NEW GENERATION BOARDING HOUSE

21-22 BURNHAM CLOSE
THORNTON NSW
ZOE MAY PTY LTD

Plan Changes from 23/11/20 to date, without prejudice:

SITE ANALYSIS

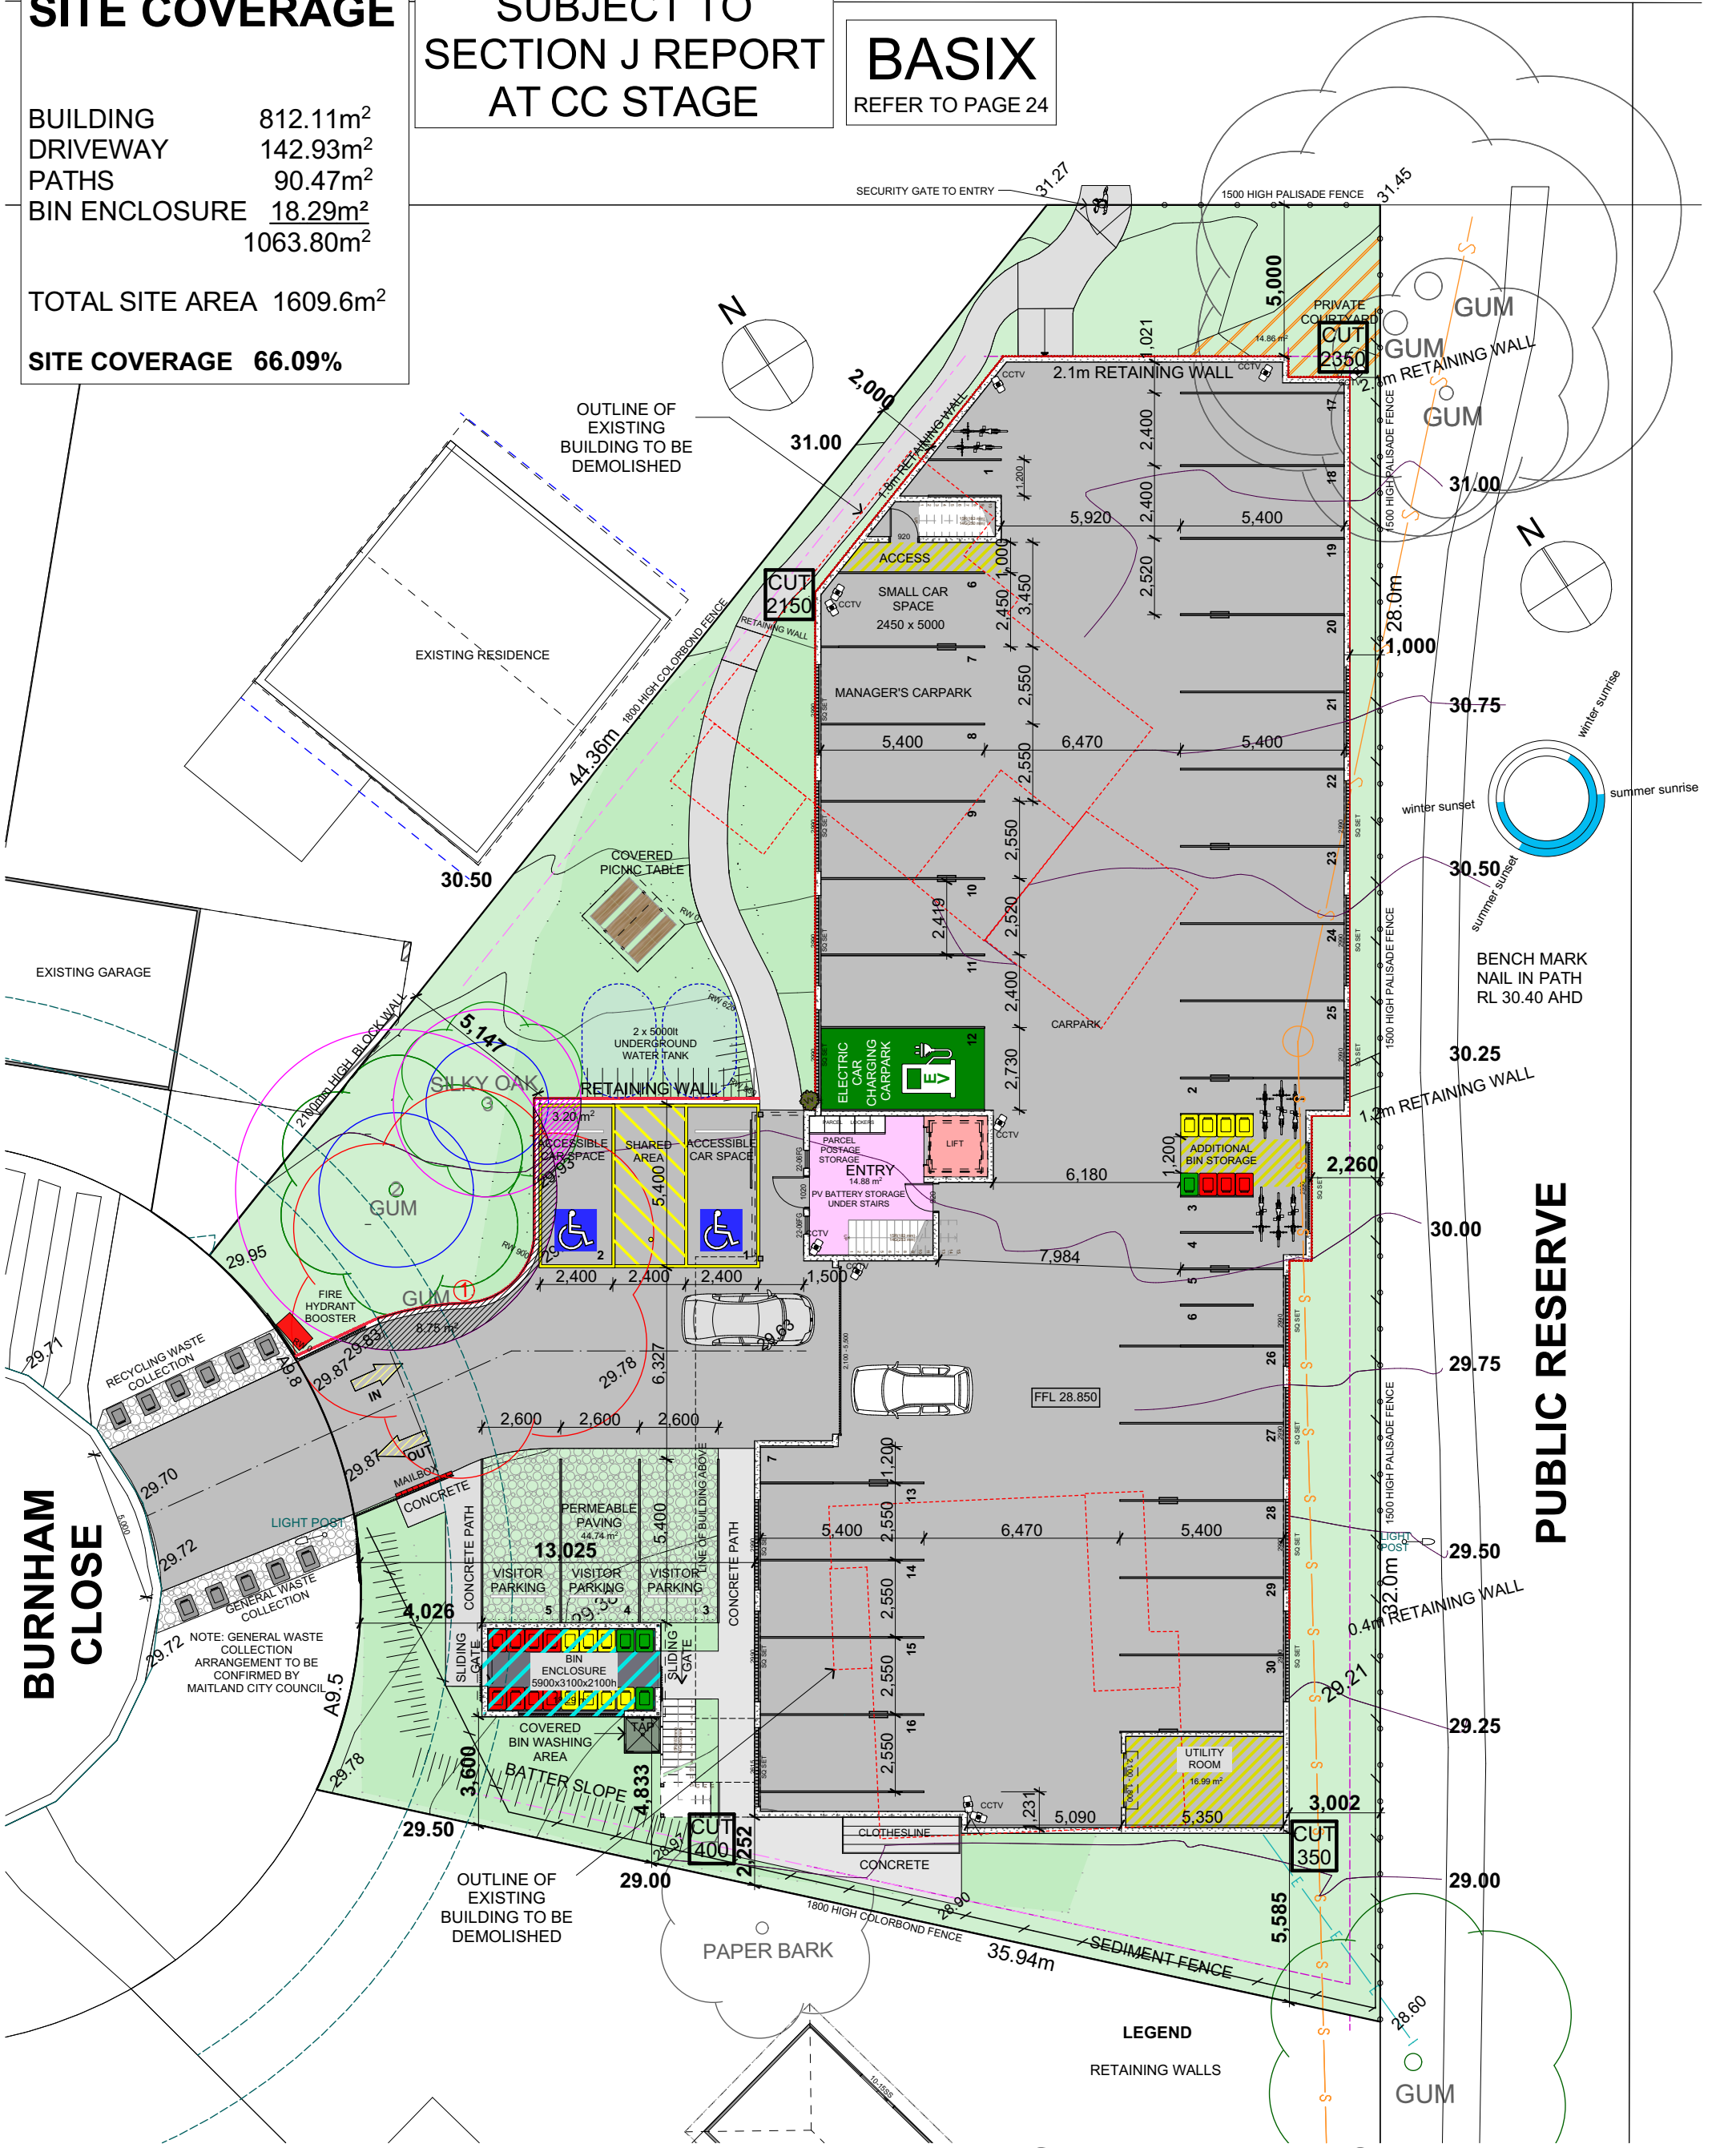
- Add additional shadow diagrams.
- Add tree protection zones to Site Analysis Plan.
- Move the first floor of the south western end of the building towards Burnham Close to increase the setback to the boarding room wall at that end to 5m.

SHADOW COMPARISON I

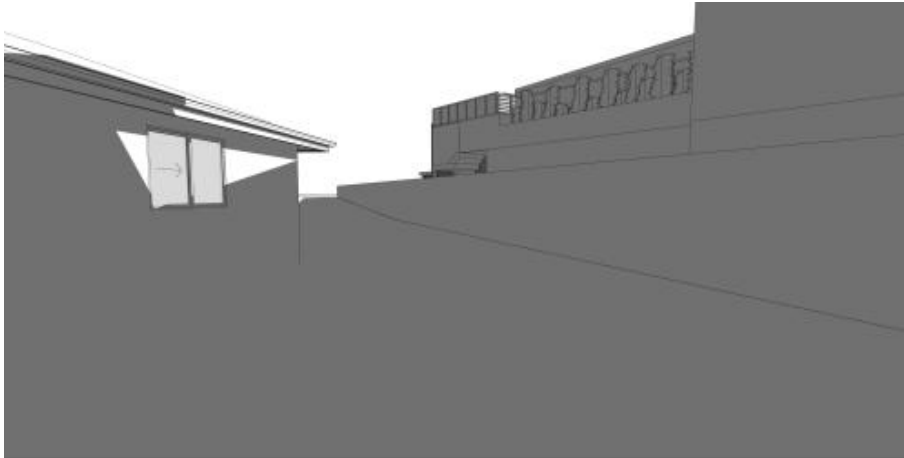
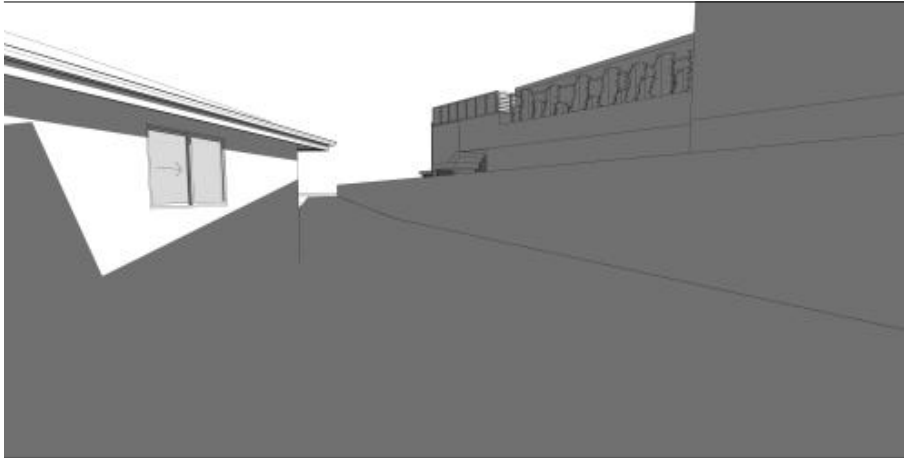
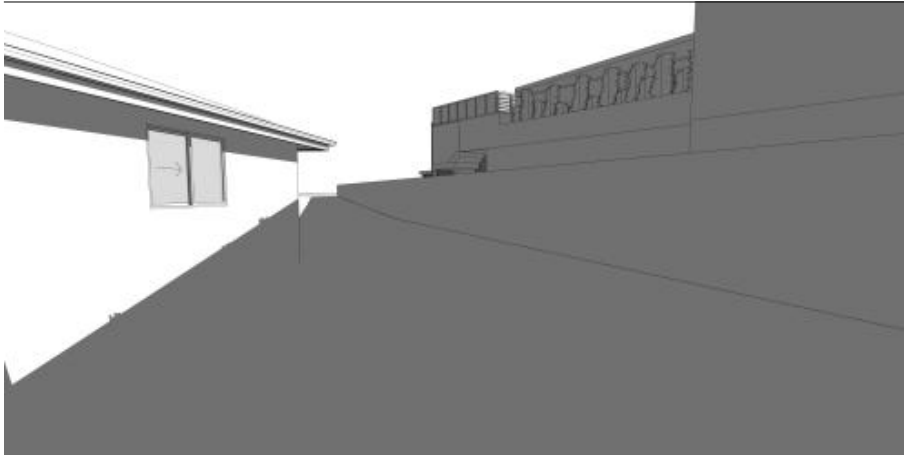
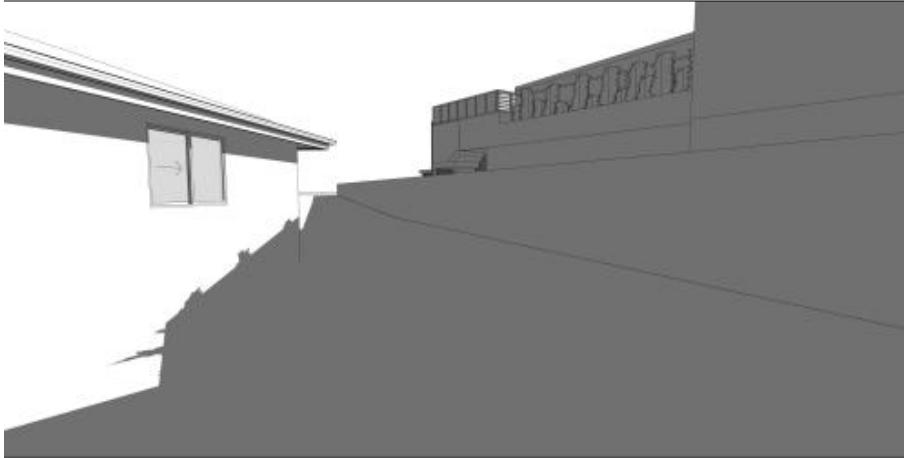
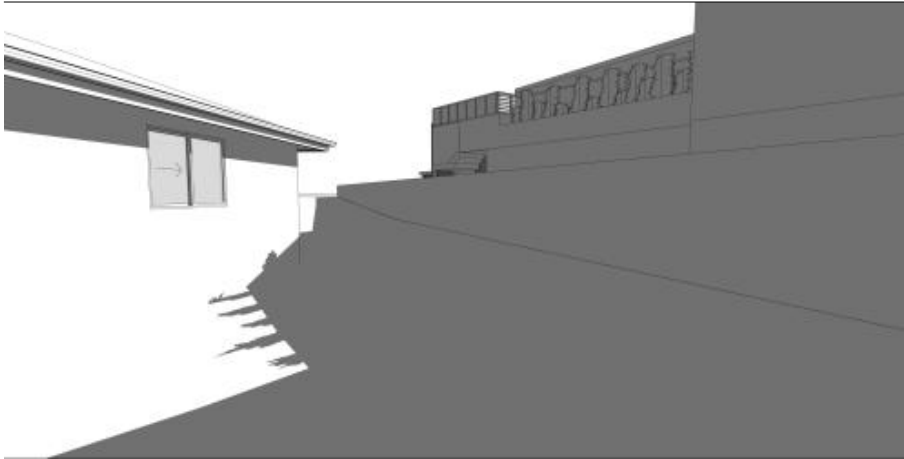
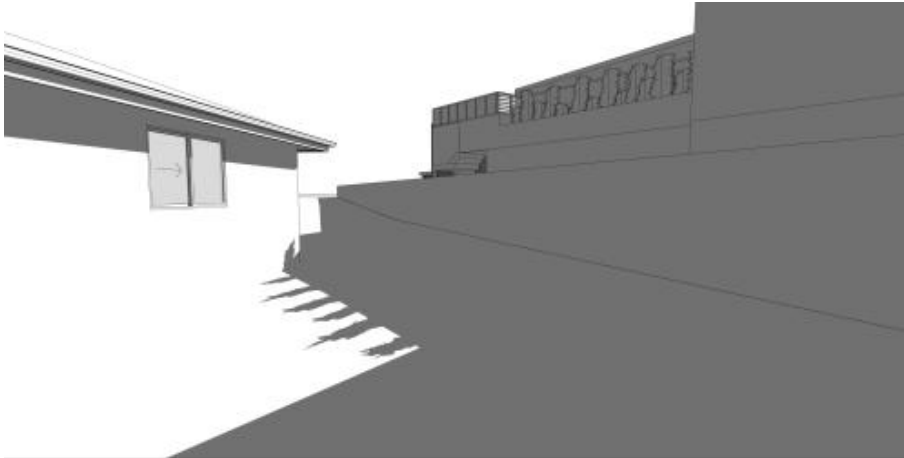
- Addition of communal roof space
 - Add shadow comparison to show solar access is maintained
- Relocate the communal living area and boarding room 26.
- Add utility room to car park.

NOTE: COMPARISON SHOWING SOLAR ACCESS TO NEIGHBOURING KITCHEN WINDOW AT No. 20 BURNHAM CLOSE

BLADE FENCE SPECIFICATION

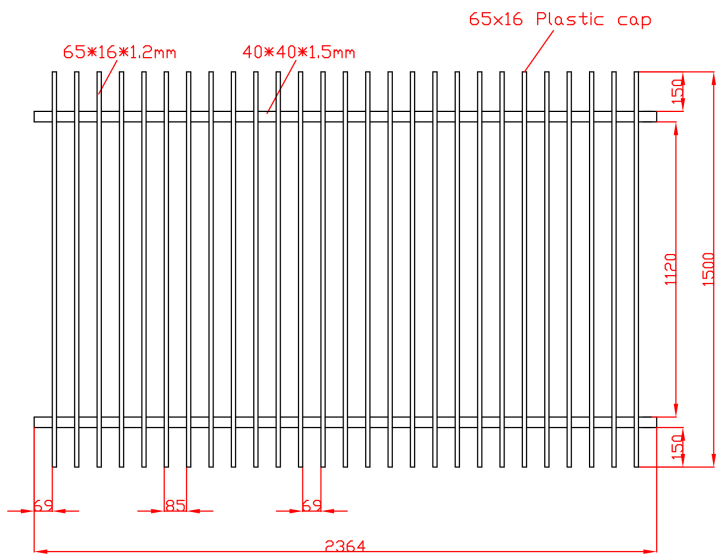
- Add proposed fence specification note to page 23.
